Lilac Pedestrian Bridge  
Hooksett, NH  
D&K Project No. 622910

ADDENDUM NO. 2

March 3, 2017

**WETLANDS  
IMPACT  
PLAN**

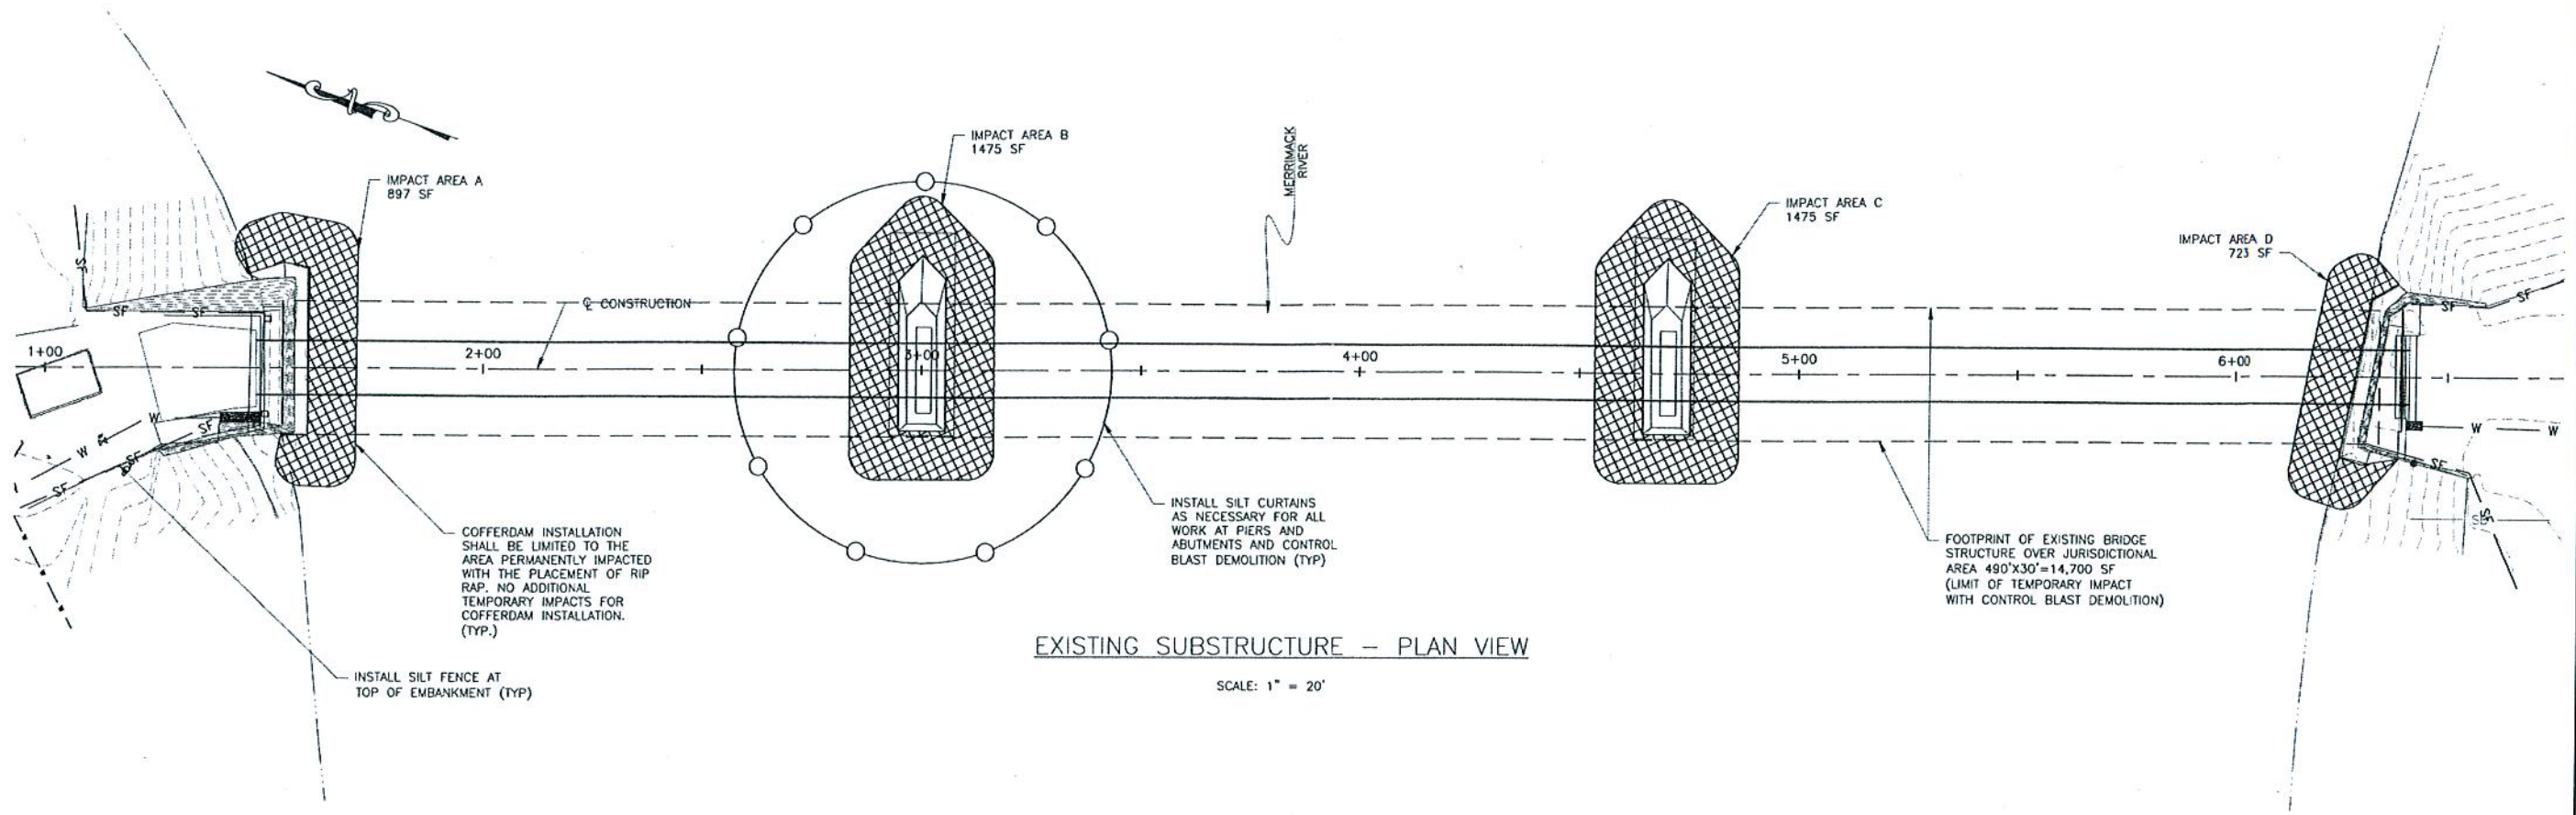
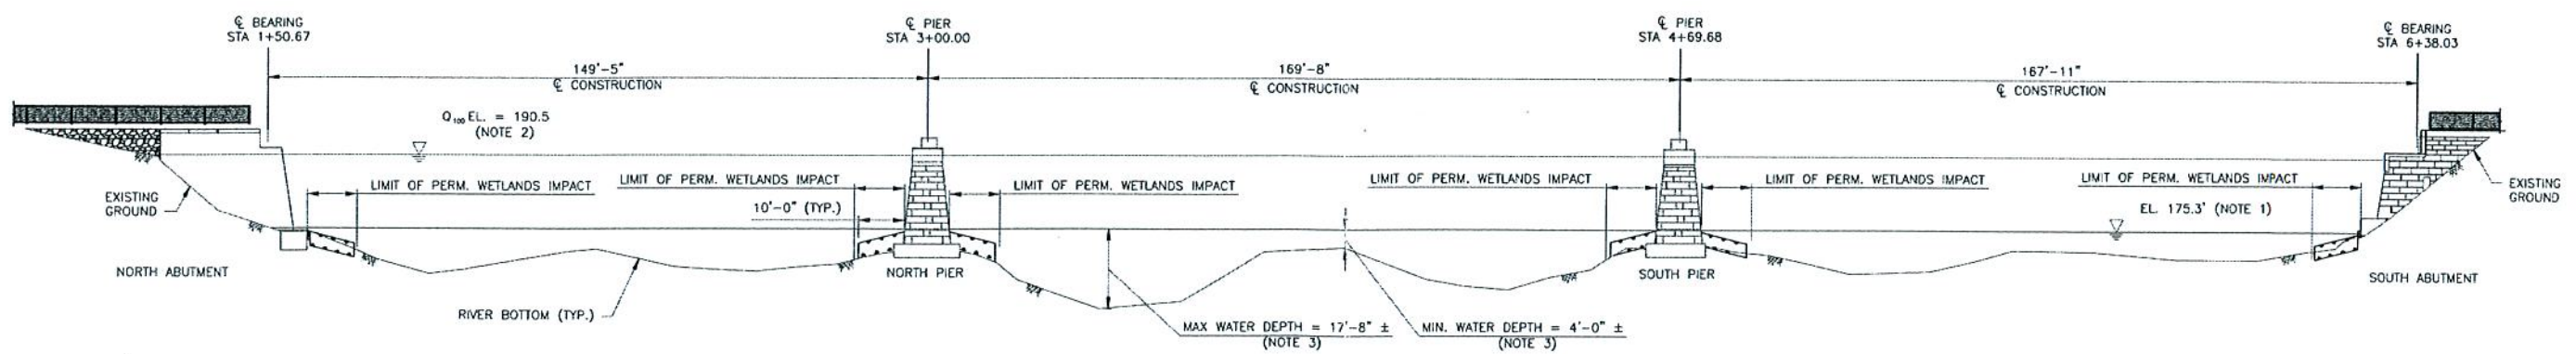
1. The limits of temporary impact consist of the existing bridge's footprint. This area may be used for Control Blast Demolition impacts. See attached **Wetlands Impact Plan** that was submitted with the Permit Application and has become part of the Permit issued by NHDES.

2. No allowance was made for any temporary impacts to the stream banks on either side of the abutments in the permit application. It was assumed that the bridge would be removed by barge or pulled from the river from above/behind the existing abutments.

3. The current permit does not allow for a temporary causeway to be constructed. It is unknown at this time if a causeway will be permitted by NHDES. The Contractor is responsible for obtaining approvals from appropriate agencies as a result of changes to the project's impact areas, types, and/or locations that were identified in the approved permit application.

4. Silt booms (Item 699.1) are required around the two piers for placement of the riprap. Silt booms or cofferdams (Item 503.2) are required in front of the two abutments for placement of the riprap. Silt booms are required to control sediment associated with Control Blast Demolition.

5. Cofferdams are required in front of the two abutments for construction of new concrete toe walls
